**SUBJECT:** NuScale Power, LLC Response to NRC Request for Additional Information No. 110 (eRAI No. 8932) on the NuScale Design Certification Application

**REFERENCE:** U.S. Nuclear Regulatory Commission, "Request for Additional Information No. 110 (eRAI No. 8932)," dated July 30, 2017

## **Response to Request for Additional Information Docket No. 52-048**

**eRAI No.:** 8932

**Figure 1:** Isometric View of South Side of Triple SAP2000 Model (Looking Northeast)

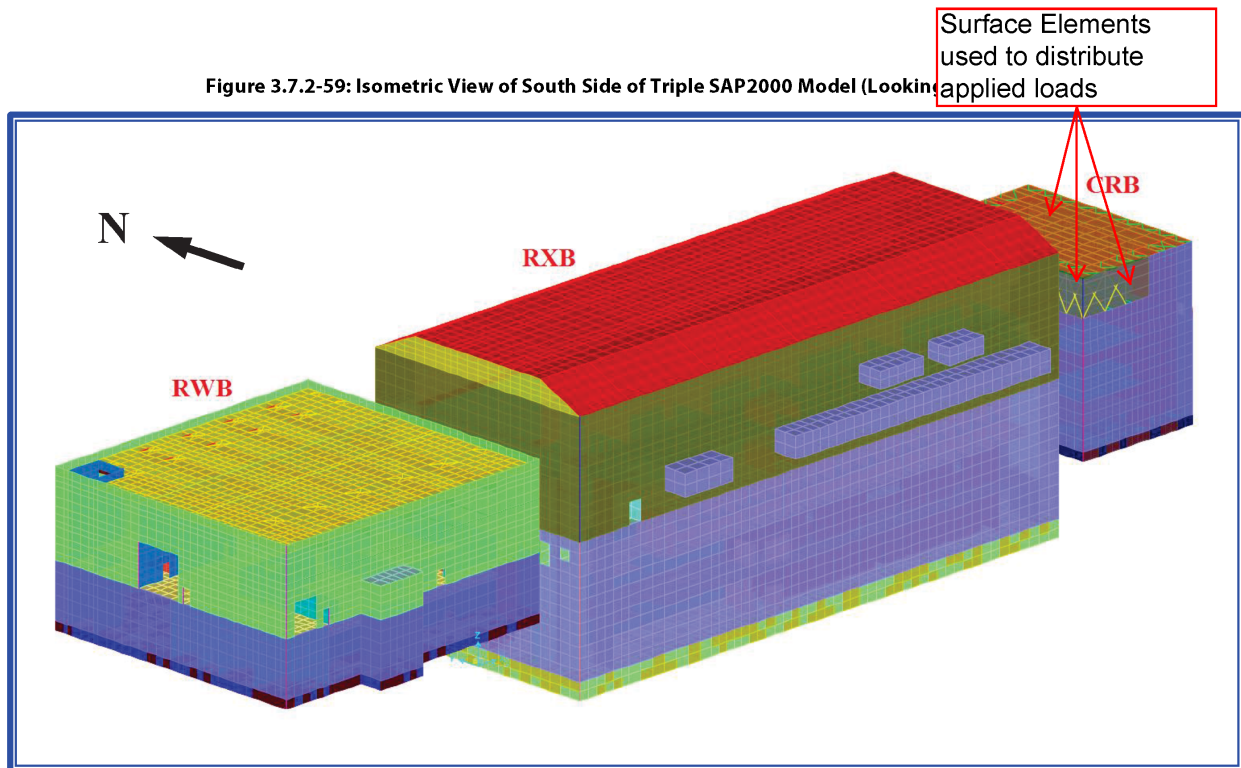
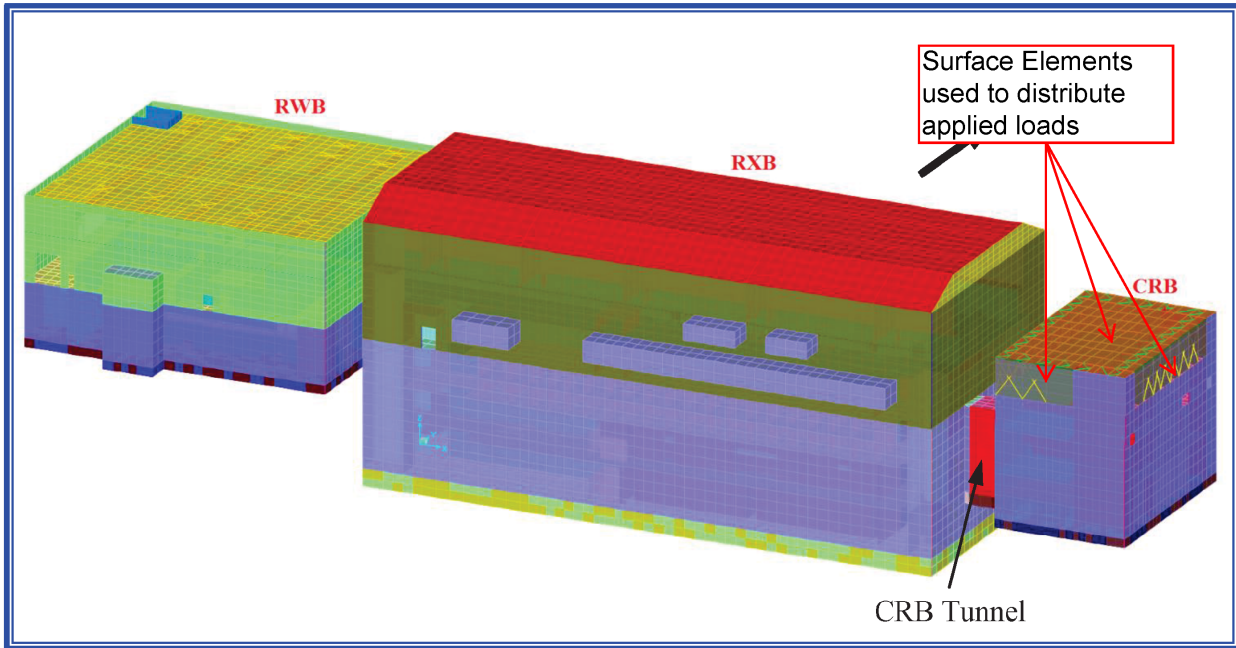
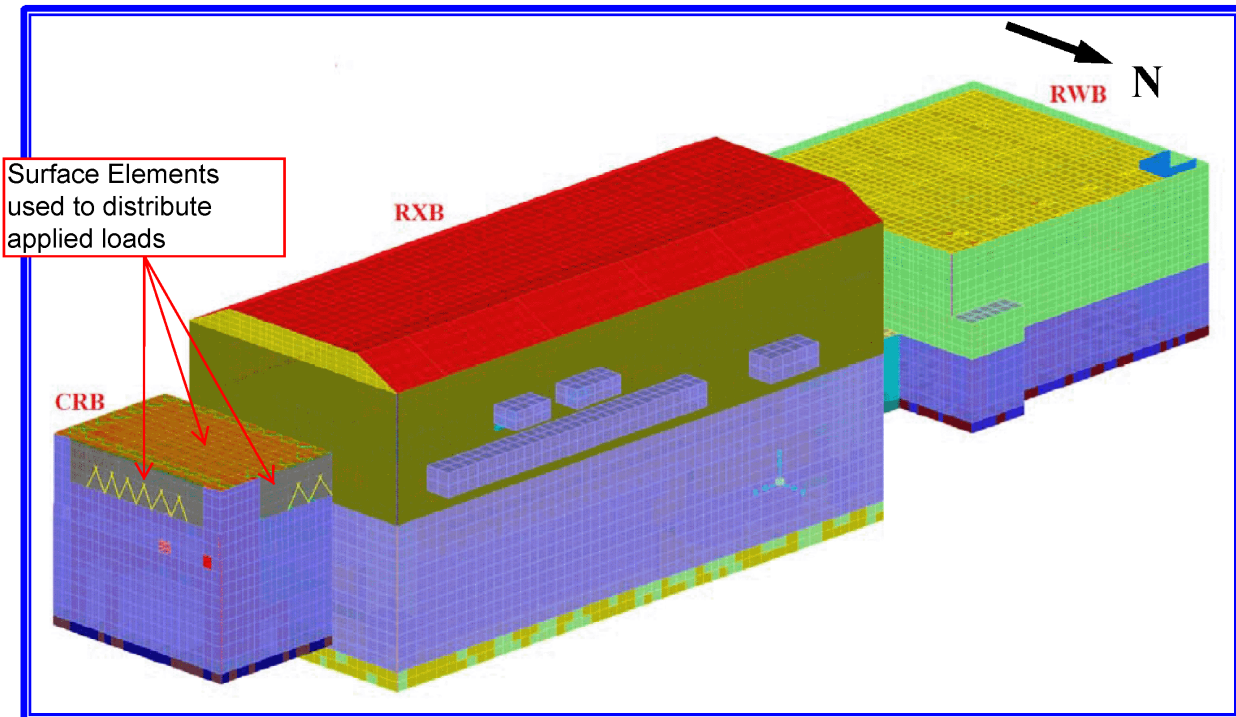
On Page 3.7-20 of the FSAR, in the third paragraph, the applicant states, “The building models have element sizes that are similar to the 6.25 feet layers that were used to determine the wave passage frequency of the soil. There are instances where development of the model required individual elements to have a dimension as large as 12 feet in the RXB and as large as 20 feet in the CRB. However, the typical element size is approximately 6 feet. Therefore the wave passage frequencies of both buildings is above the cut-off frequencies used for the analysis.” For elements that have a dimension of 12 ft or 20 ft, the applicant is requested to provide the elements locations in the building, and explain how the presence of these coarse elements do not affect the results of seismic demand analyses for the RXB and CRB.

FSAR Tier 2, Section 3.7.2.1.1.3 describes element sizes used in the SASSI2010 models. In the control building (CRB) model, the elements with large dimensions or aspect ratios are non-structural areas or membrane elements used for the purpose of applying wind loads to the steel beams and columns of the steel frame structure above elevation 120 ft. The 20 ft elements are located on the north and south walls whereas the 12 ft elements are located on the east and west walls above elevation 120 ft. Similar surface area loads are applied to the CRB roof to evenly distribute applied loads. The loads are applied as surface pressure on these areas and then transferred to the structural elements through the shared nodes. These coarse elements are not present in the seismic analyses and will therefore not affect the seismic demand results. FSAR Tier 2, Figures 3.7.2-59 through 3.7.2-61 show the surface elements used to distribute the applied loads. The elements in grey represent the surface areas in the North-South and East-West direction and the orange elements represent the surface areas used in the CRB roof. The locations have been identified in Figures 1 through 3 of this response.

Figure 3.7.2-20: Half of Reactor Building SASSI2010 Model without Hidden Lines

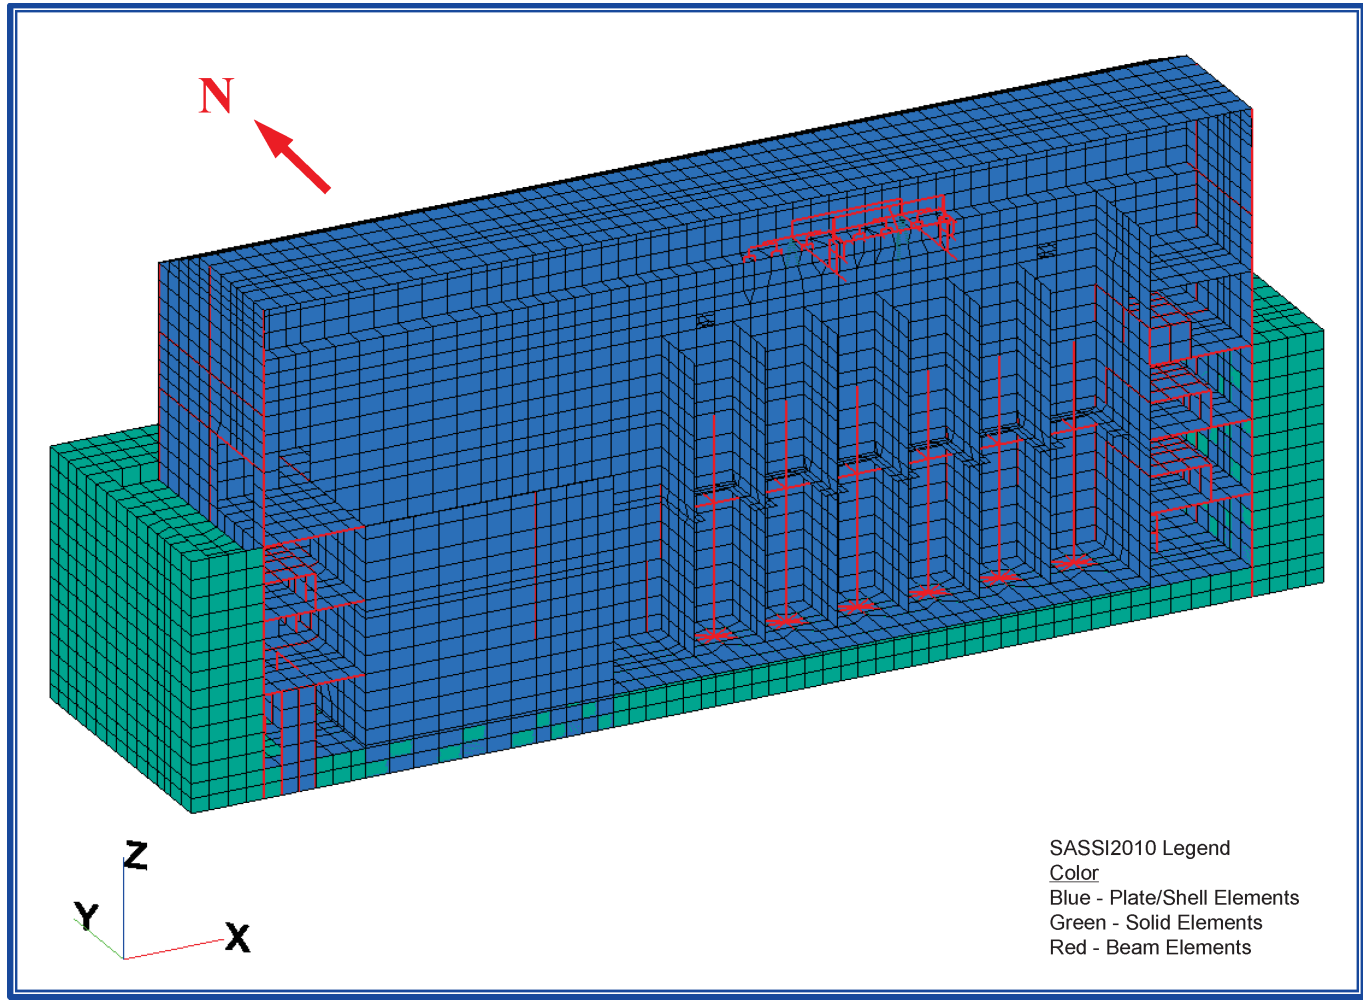
- d. In Figure 3.7.2-20 in the FSAR, The applicant is requested to clarify if the bottom two layers represent the basemat which is to be considered as part of the RXB and color-coded accordingly (in blue). The figure also appears to show mixed coloring for certain elements in the bottom two layers. Please explain what the mixed colors represent for these elements.

- d. The 10 ft thick RXB basemat foundation is modeled by two 5 ft thick layers of Solid elements. The RXB outer walls, pool walls, and all the walls connected to the foundation are modeled as shell elements and start at the bottom of the foundation level. Similarly, all pilasters (Beam elements) start at the bottom of the foundation. All groups of Solid elements are shown in green, groups of Shells are shown in blue, and Beam elements are shown in red. The backfill soil and foundation Solid elements are, therefore, all green. Due to the limited capabilities of the SASSI2010 model geometry plotting program, the graphical perspective views of the finite element analysis (FEA) model may cause color overlapping. FSAR Tier 2, Figure 3.7.2-20 is revised to include a legend for the Shell, Solid, and Beam elements.

FSAR Tier 2, Figure 3.7.2-20 has been revised as described in the response above and as shown in the markup provided in this response.
